RE: 2010 Annual Inspection, and Report on 6B Construction for the Mount Polley Mine

TAILINGS STORAGE FACILITY
REPORT ON STAGE 6B CONSTRUCTION

**TAILINGS STORAGE FACILITY
REPORT ON STAGE 6b CONSTRUCTION
(REF. NO. VA101-1/29-1)**

VA101-1/26 DRAWING NO. 226 REVISION 1

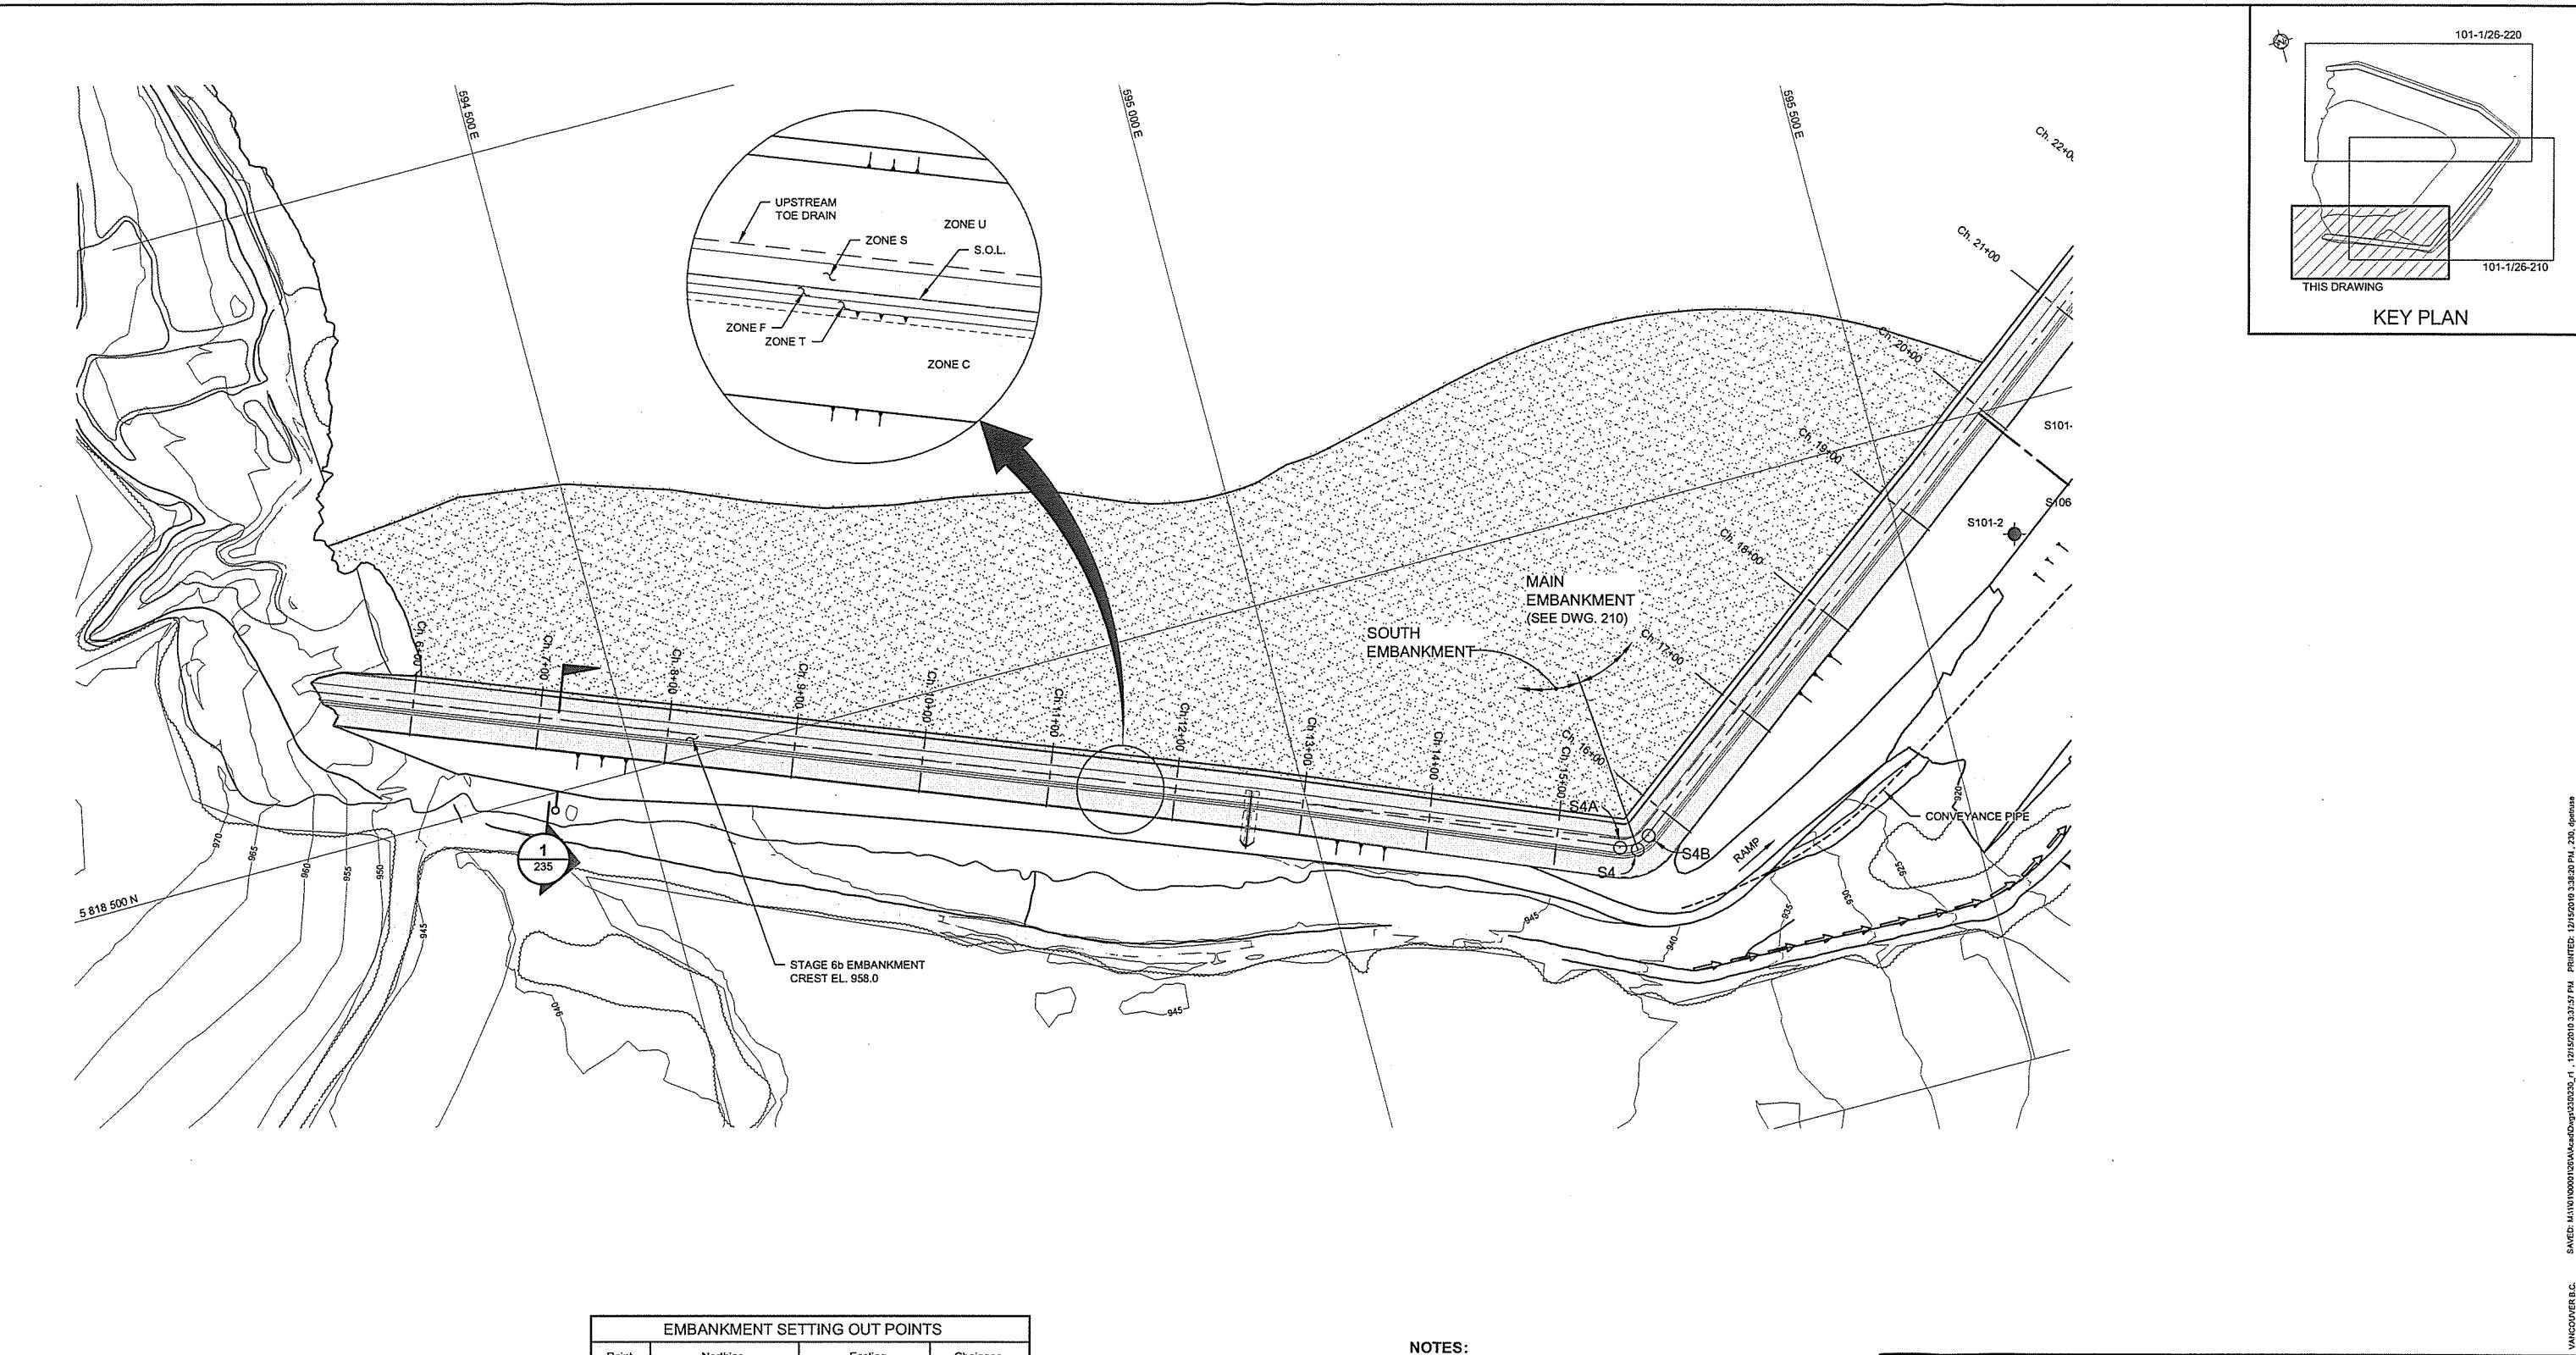
| <p>MPMC would like to replace The remainig Stage 6b and all stage 7a Zone U till with mine waste rock. The new design will have the Zone u constructed prior to till placment.</p> <hr/> <hr/> <hr/> | | | |
| Reference Drawings / Clauses: | <u>See drawing 226</u> | | |

The design change to use waste rock for a reduced width zone U is approved with amendments. The amendments are shown on the attached sketch and summarized as follows.

- Maintain a minimum 5m crest width of zone U. Increase zone U crest width as required for haul traffic.
- Place and compact zone U as for zone C. Place in 2m lift max, compaction by haul traffic.
- Maintain a slope of 1H:1V or flatter on the zone U to zone C interface.
- Remove all particles larger than a coarse gravel, (+75mm or +3") from the interface between zone U and zone C.

PANO. VA101-1/26 DRAWING NO. 235 REVISION 0

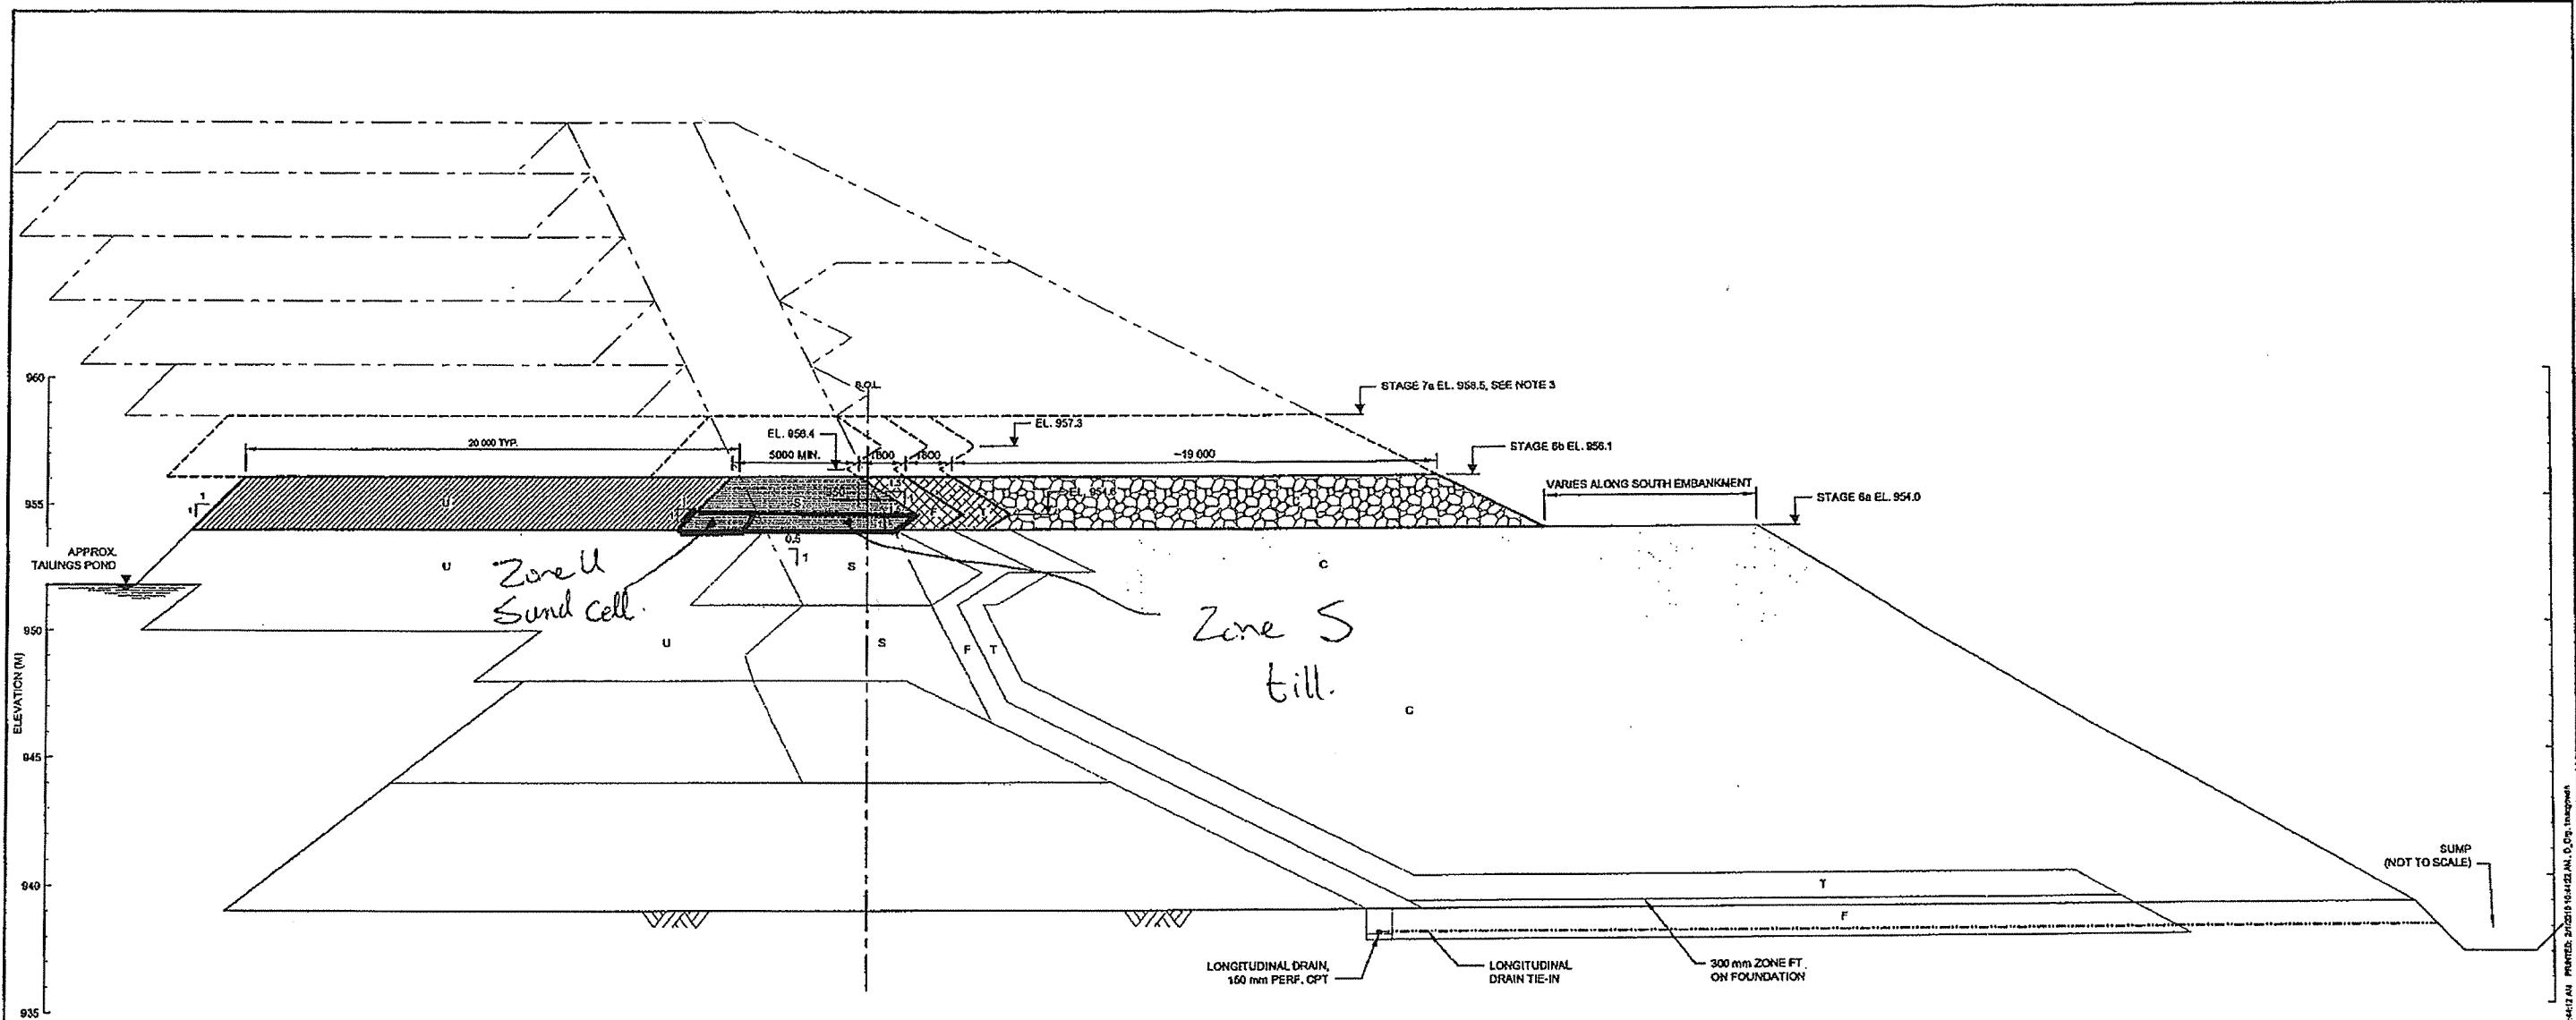
| MPMC would like to replace Zone U till with sand cell construction below elevation 954.6m. | | | |
| Reference Drawings / Clauses: | See drawing 235 | | |
